CITY OF PORTLAND, MAINE ENGINEERING REVIEW FORM

Proposed Self-Storage Units - Bruce Pike, 24 Morrill Street

SELF-STORAGE FACILITY 24 MORRILL STREET PORTLAND, Maine

Site Plan Review Self Storage Facility 24 Morrill Street

SUBCATCHMENT 10 RUNOFF Portion of site to be developed

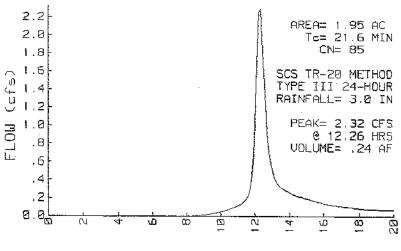
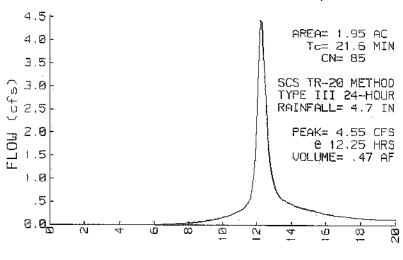
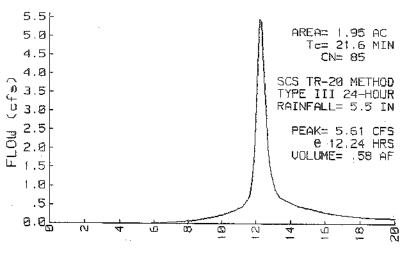
- c. The sheet flow component for existing watershed 10 seems long; based on the contours I would estimate it to be approximately 90°. Also this observation seems appropriate when comparing the Tc's between watersheds 10 and 20. The difference between the Tc's seems to be too large.

- c. The sheet flow Tc were not altered from the suggested. We believe the Tc shown for the existing flow is longer than needed, but provides a conservative estimate which will limit the post-development to a lower allowable released runoff rate. A shorter Tc would allow more water to be allowed off site in the post-developed condition.
- d. We have reviewed the off-site contribution to the culvert crossing the railroad tracks near our outlet from the proposed detention pond. Based on our site visit, estimated measurements, and topography, the culvert handles both land from the abutting gas station and railroad tracks. Calculations for the 24" culvert shown as Pond 200 are included for the post-condition. Land off site contributing to Pond 200 is shown as Subcatchments 999 and 1000.
